ADDENDUM

NO. 3

PROJECT NAME: Hays High School 2025 Additions and Renovations

ADDENDUM DATE: 15 May, 2025

DIMENSION CONTROL
PLAN (1 OF 2)

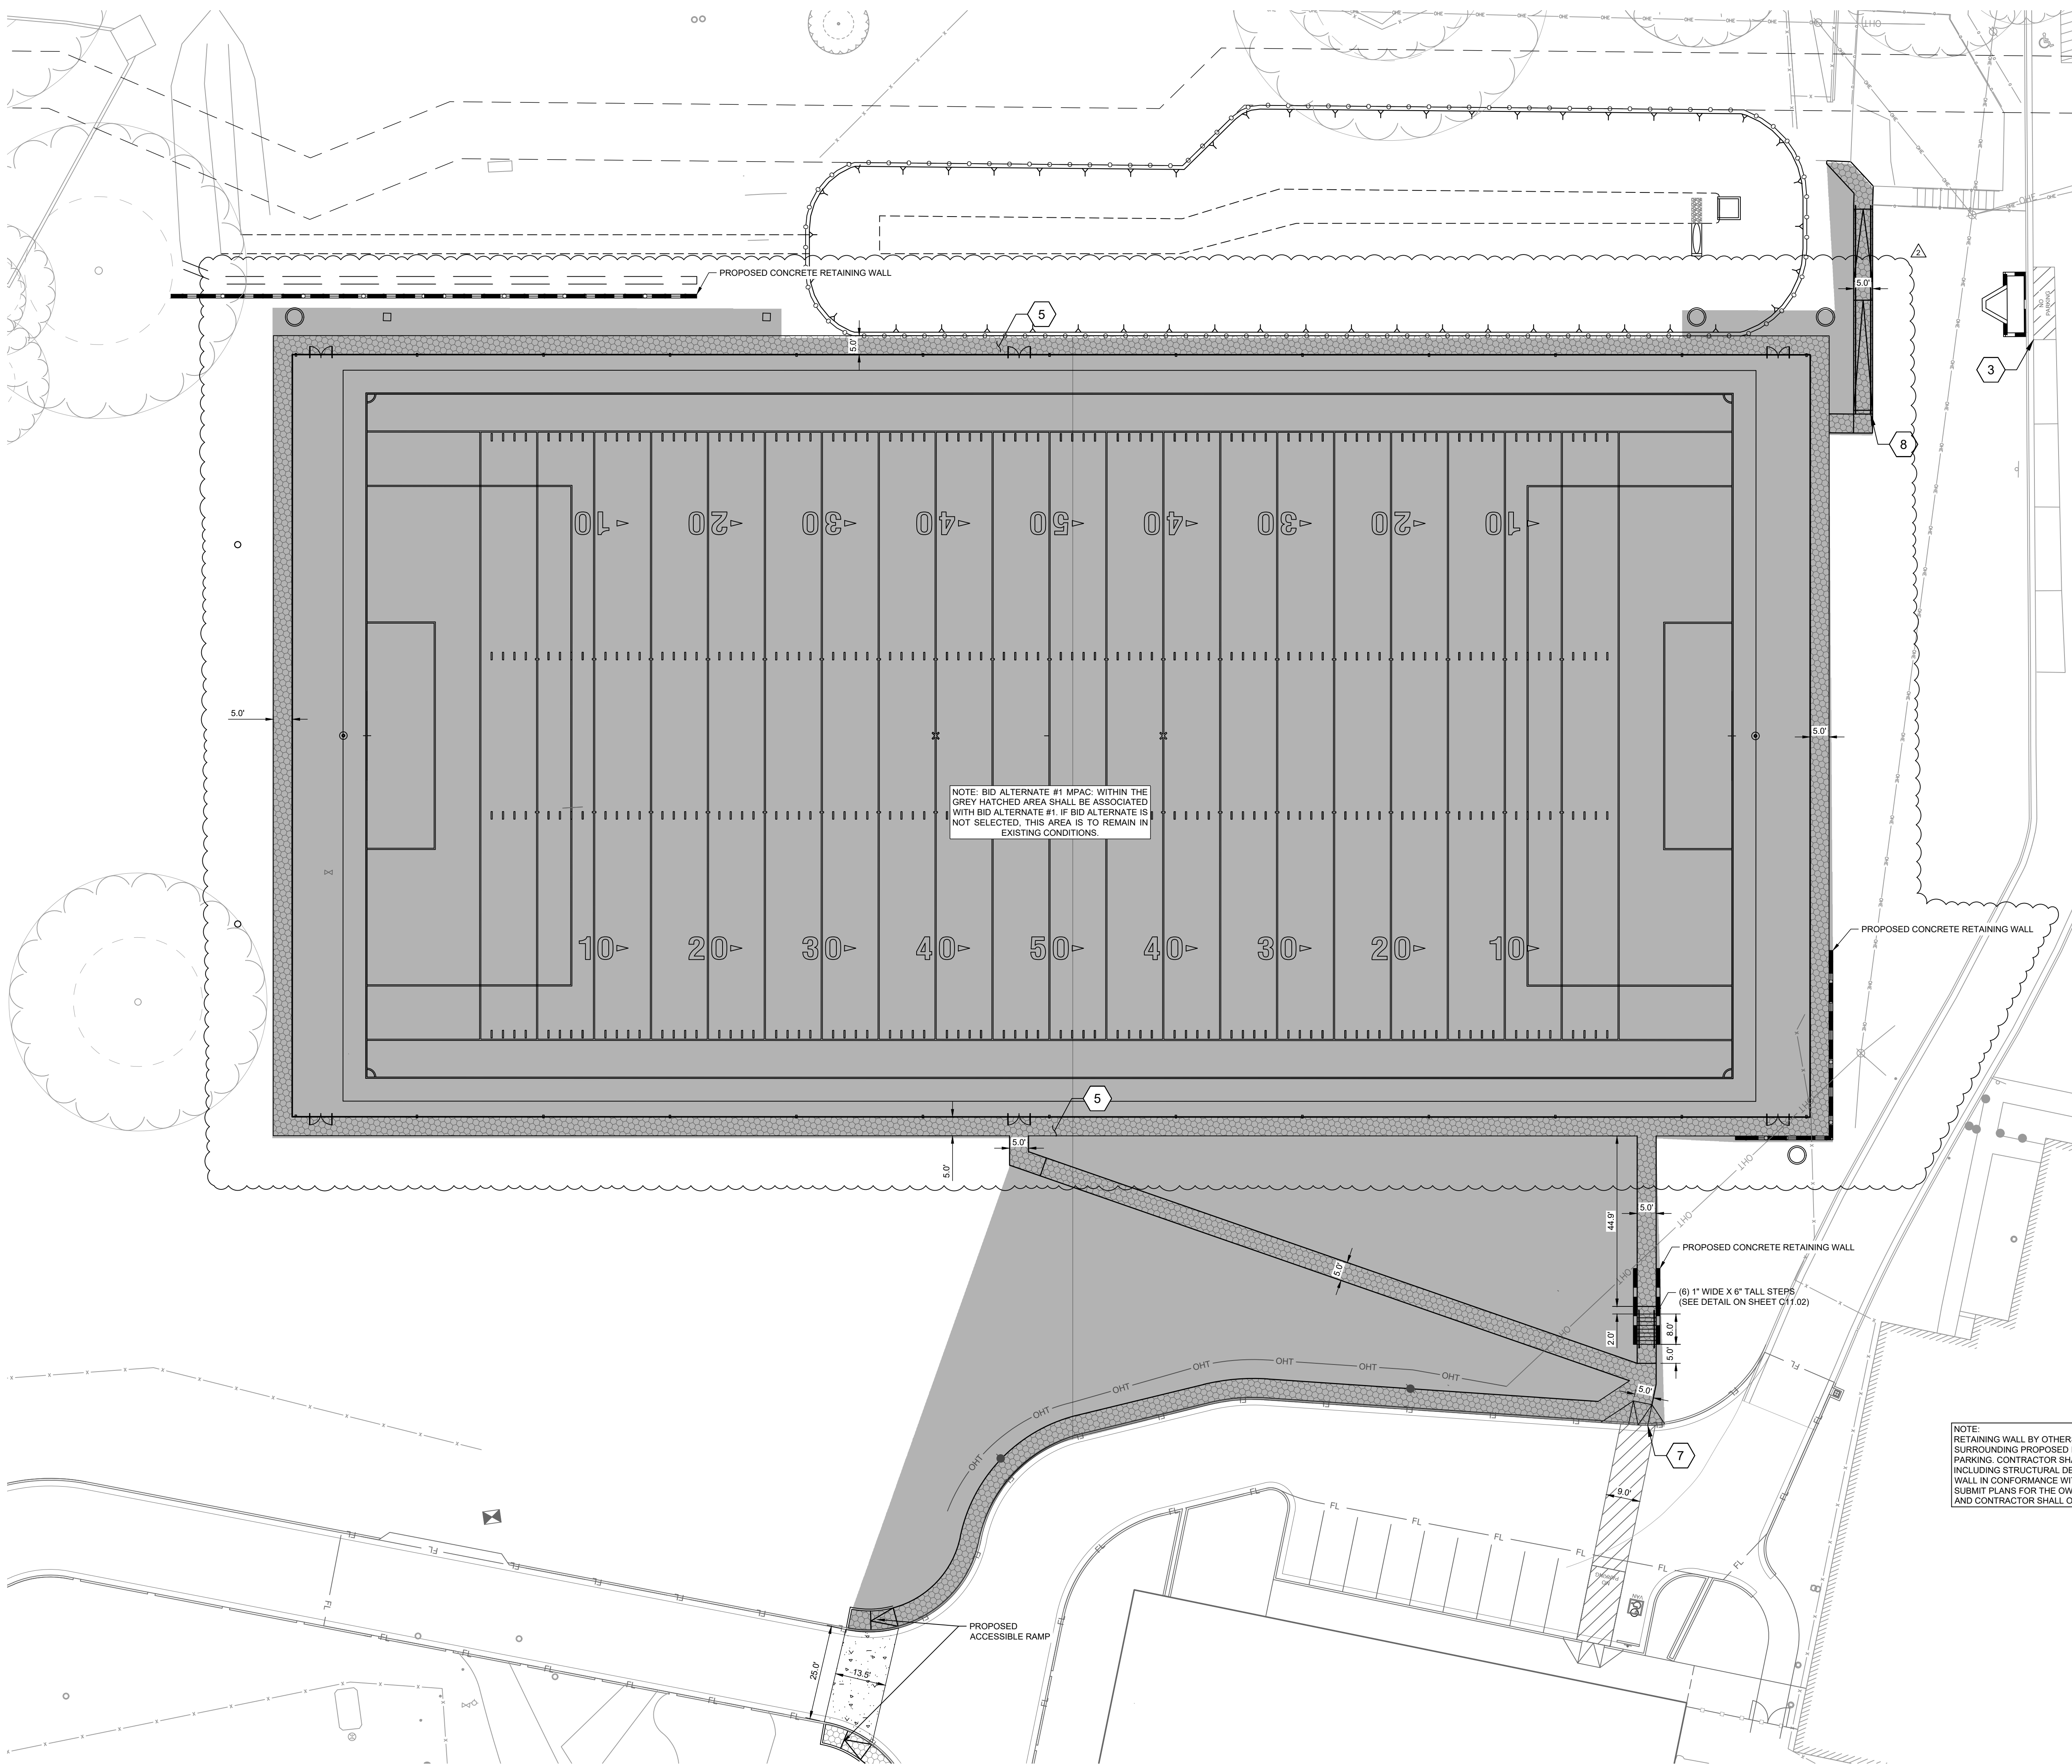
AD No 3, Civil Item 1: **To the Drawings, Sheet C4.01, "DIMENSION CONTROL PLAN (1 OF 2),"**

- 1) Modification of MAC footprint.

GRADING
PLAN (1 OF 2)

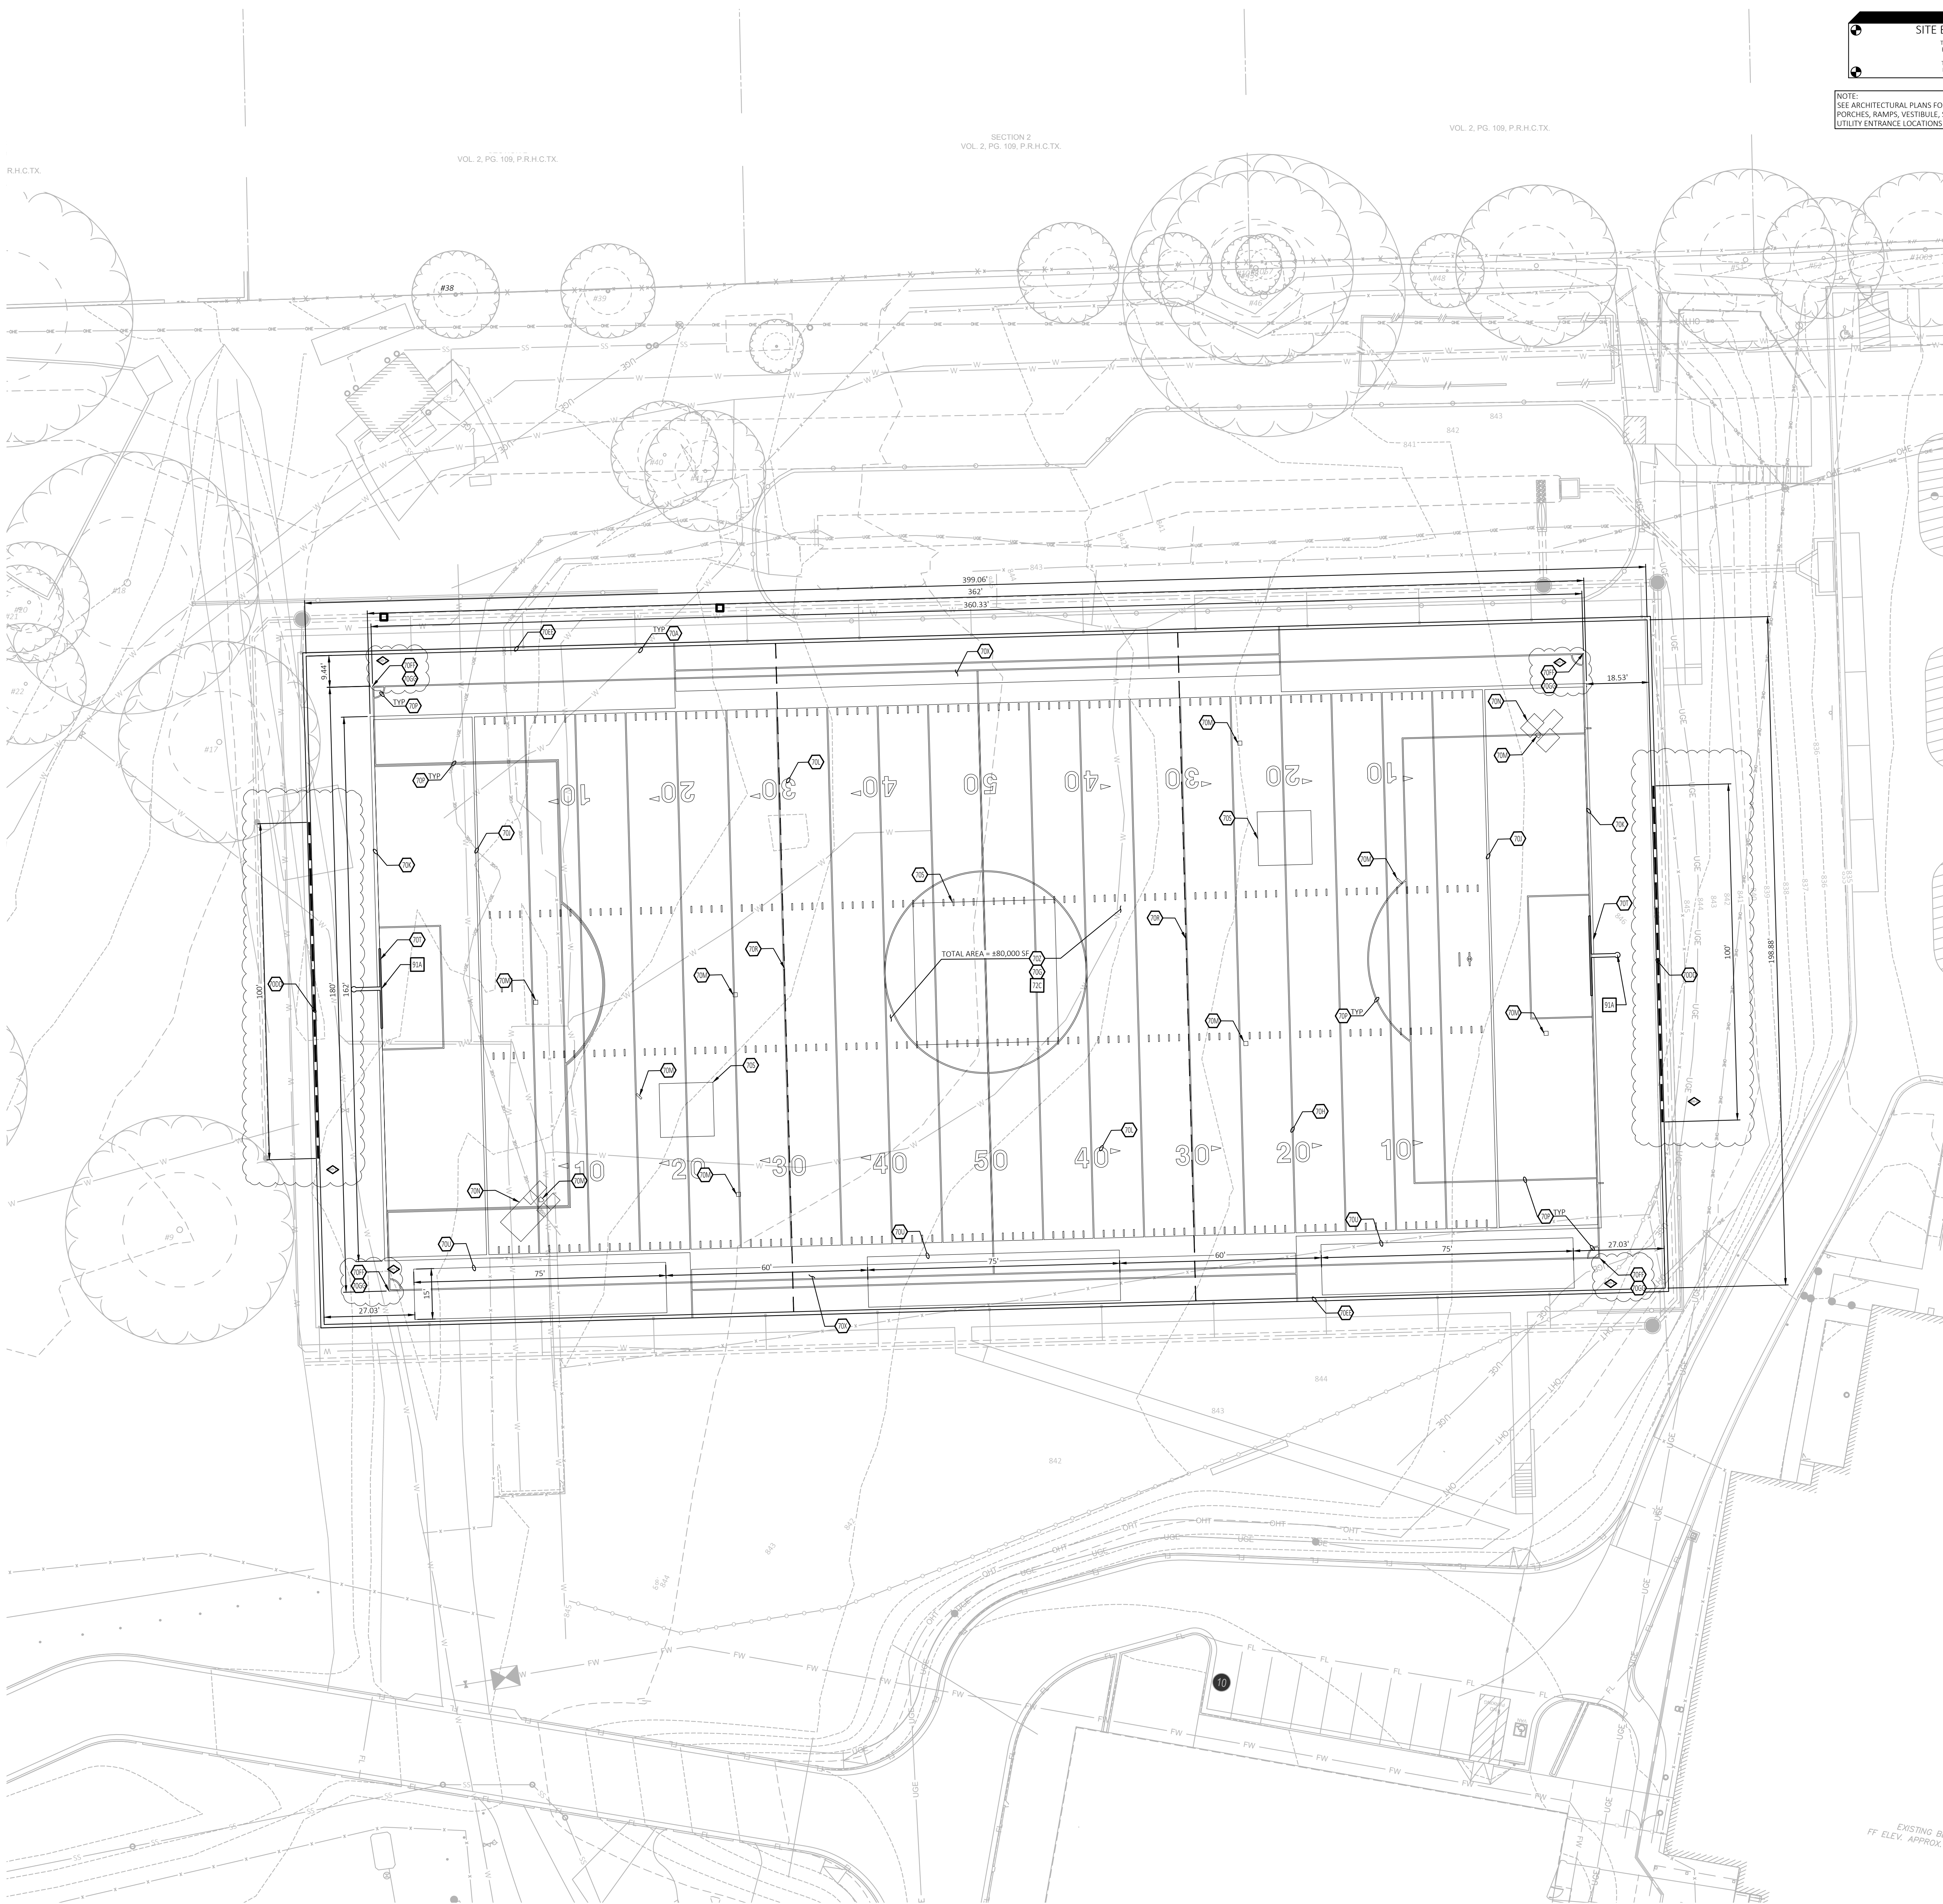
AD No 3, Civil Item 2: **To the Drawings, Sheet C6.01, "GRADING PLAN (1 OF 2),"**

- 1) Modification of MAC footprint.

1 ROOF FRAMING PLAN - AREA A

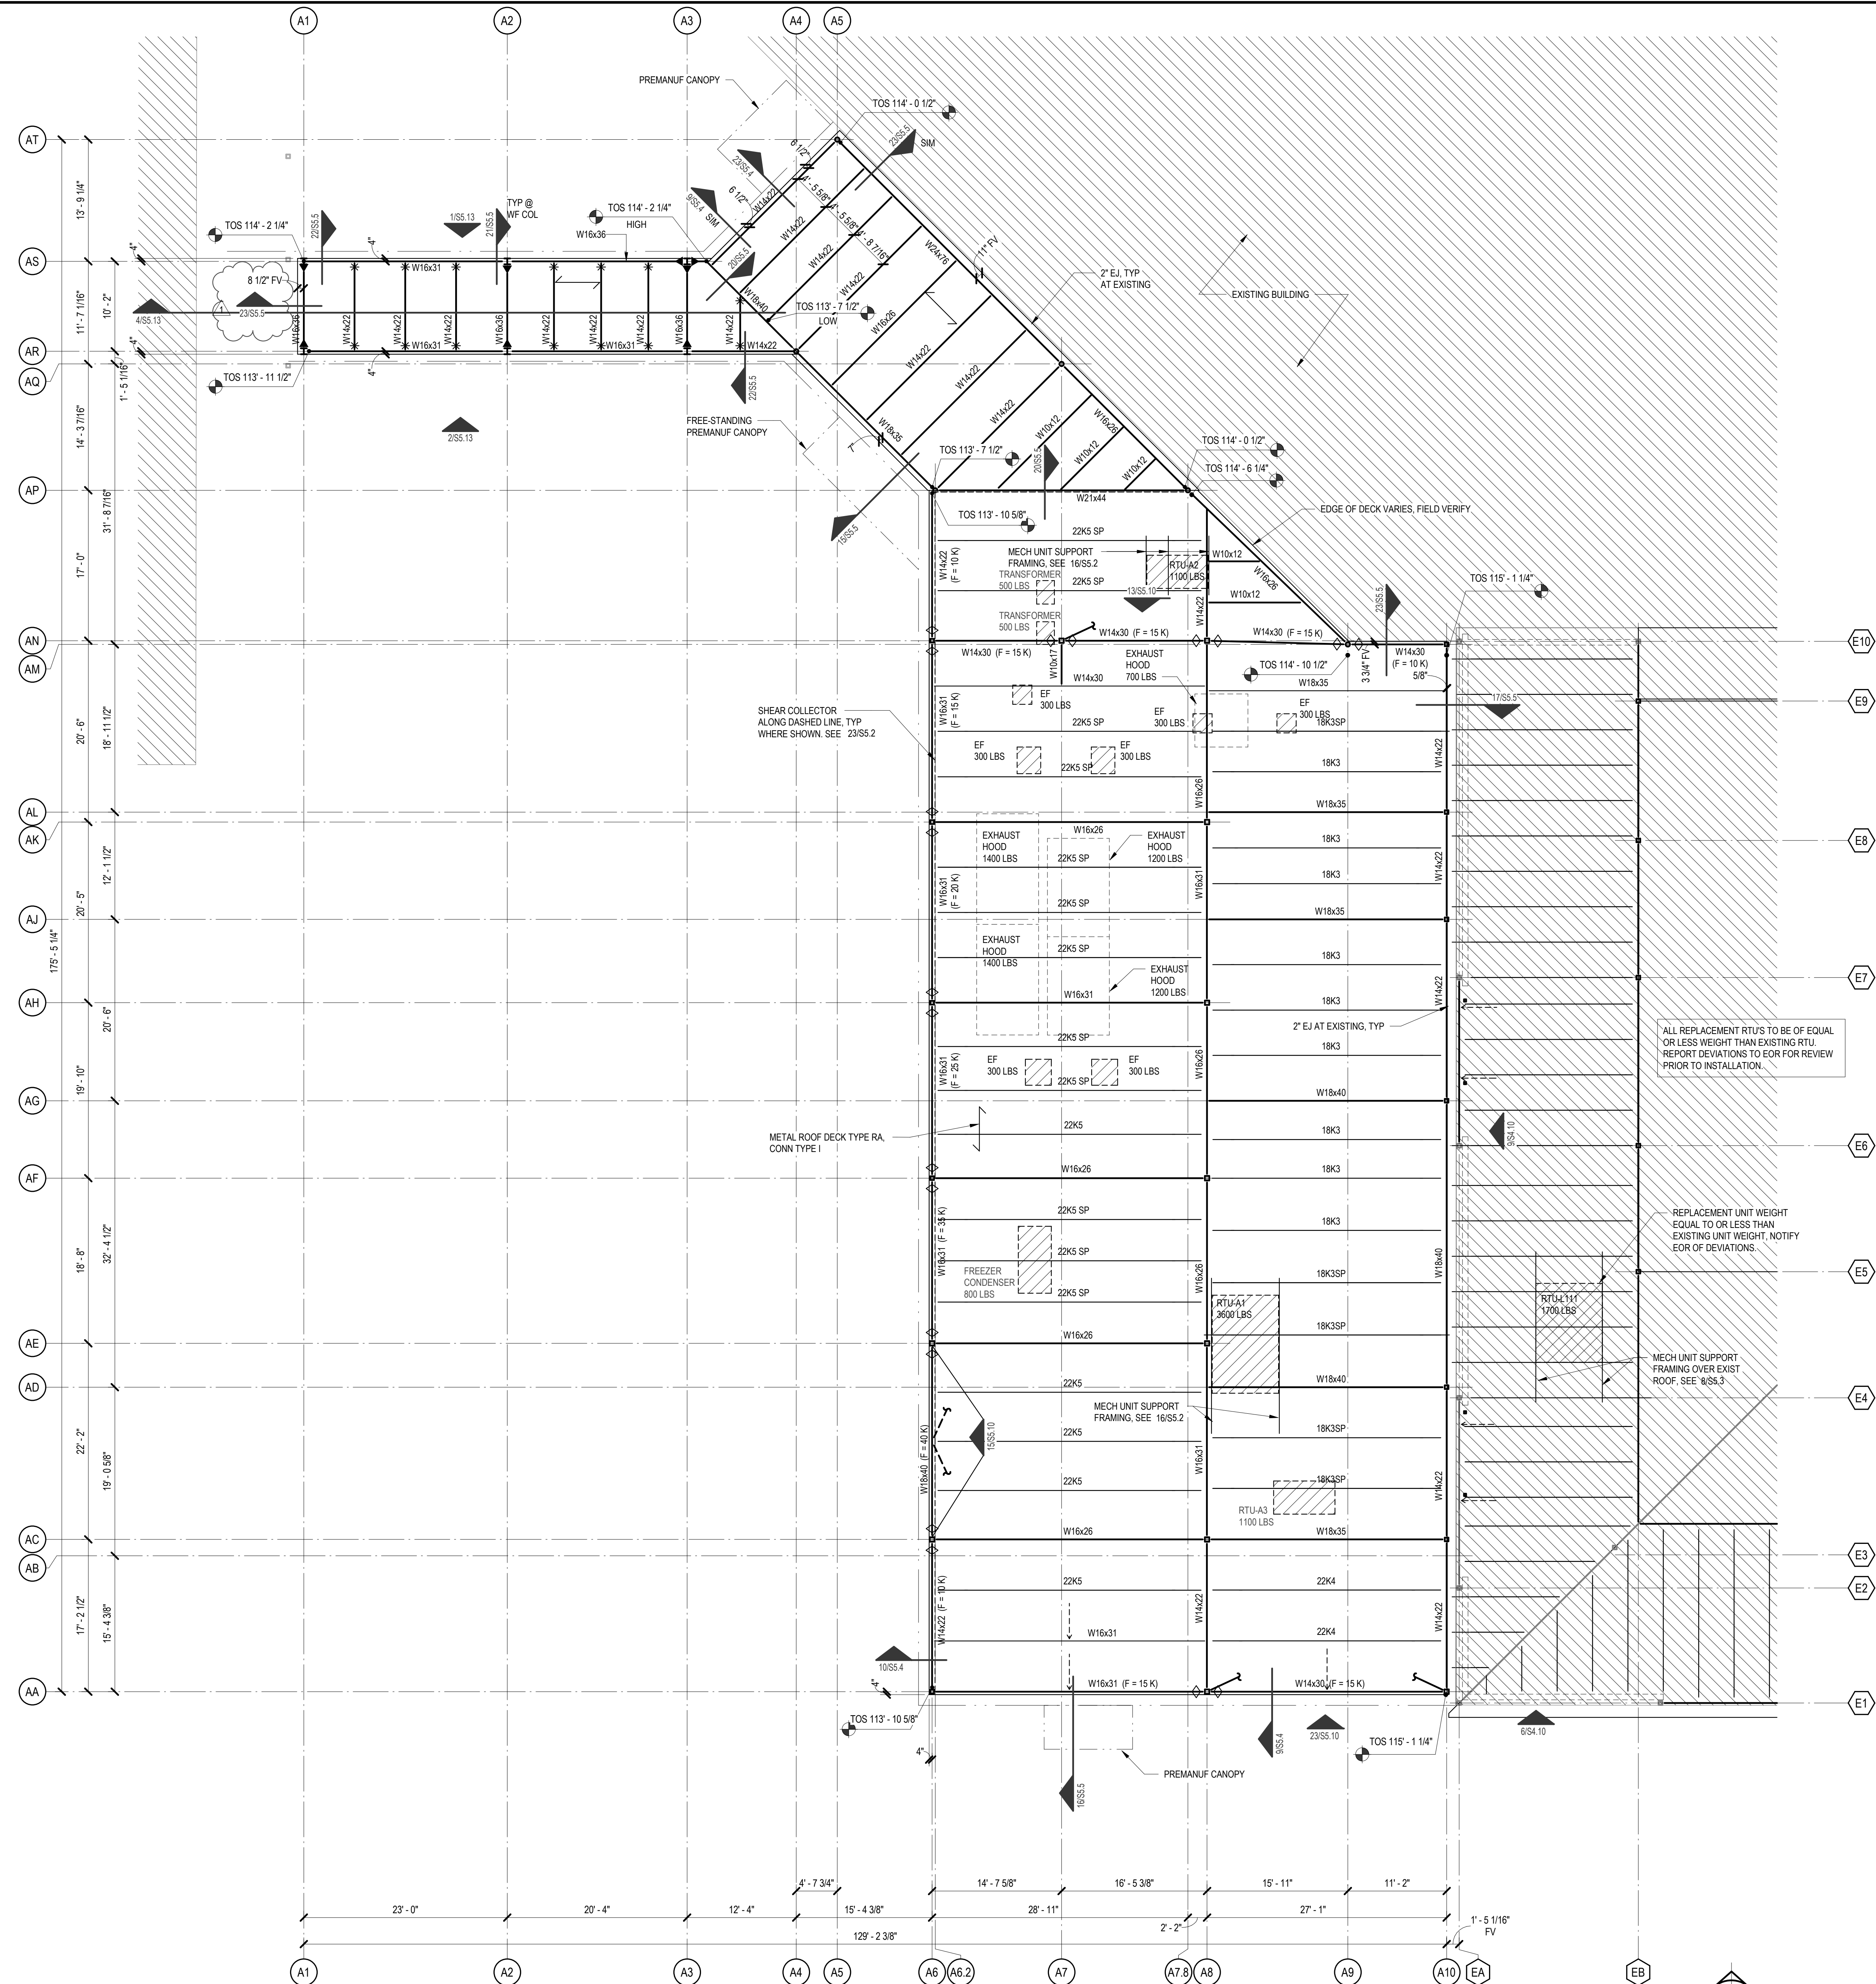
AD No 3, Struct Item 2: **To the Drawings, Sheet S2.1A2, "ROOF FRAMING PLAN - AREA A,"**

- 1) Added detail references where shown.
